**RE: V-FEE MENDHAM APARTMENTS LLC DEVELOPMENT APPLICATION
84-90 MAIN STREET
BLOCK 801, LOT 20
MENDHAM BOROUGH, MORRIS COUNTY
NJDEP FLOOD HAZARD AREA AND FRESHWATER WETLANDS PERMIT APPLICATIONS
DEP FILE NO. 1418-20.0001.1**

As you requested, One Water Consulting LLC (One Water) has reviewed the above-referenced application on behalf of the Borough of Mendham Environmental Commission, Open Space, and Shade Tree (ECOSST) Committee. V-Fee Mendham Apartments, LLC has proposed a multi-family residential development on Block 801, Lot 20 in the Borough of Mendham, Morris County, New Jersey. I understand that NJDEP has received Flood Hazard Area and Freshwater Wetlands permit applications related to the proposed project, and I have prepared this letter to provide comments related to these permit applications.

ATTACHMENT B
USGS STREAMSTATS REPORT

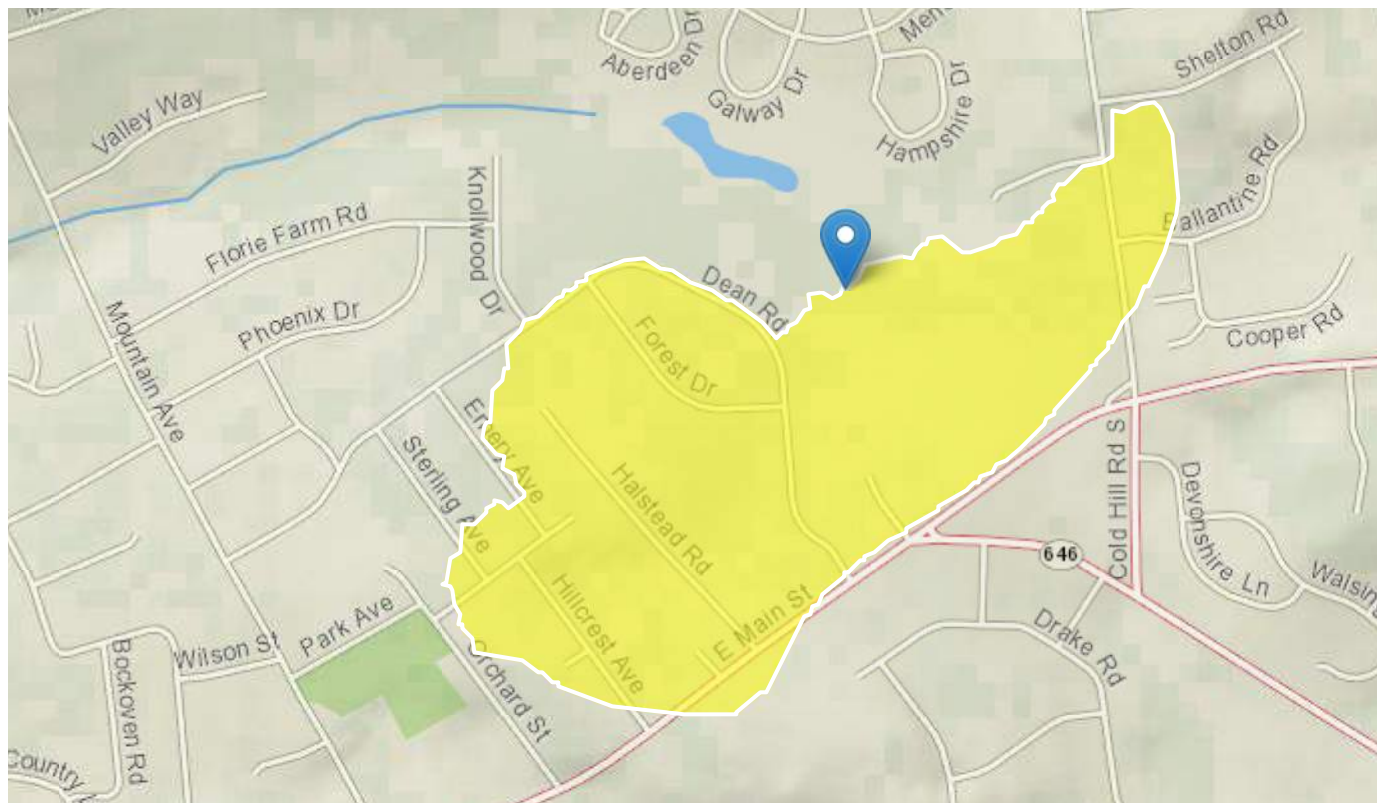
- b. We have run USGS StreamStats as a point of reference for the total drainage area to the stream at the site. The StreamStats report is provided as Attachment B which shows a drainage area of 173 acres, which is more than double the area of 75 acres presented in the Flood Hazard Area Study.
